# INTRODUCTION

## OUTLINE OF NEW FEATURES

### 1. AB60E and AB60F Automatic Transmissions

**Condenser Assembly**

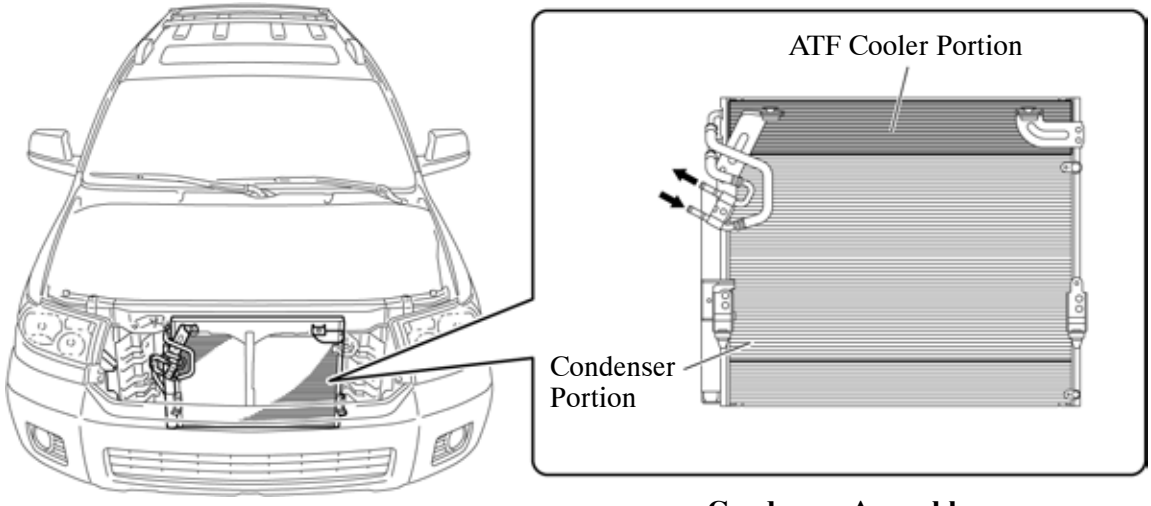
The specification of the ATF cooler has been changed to make an air-cooled type ATF cooler which is integrated with the condenser.
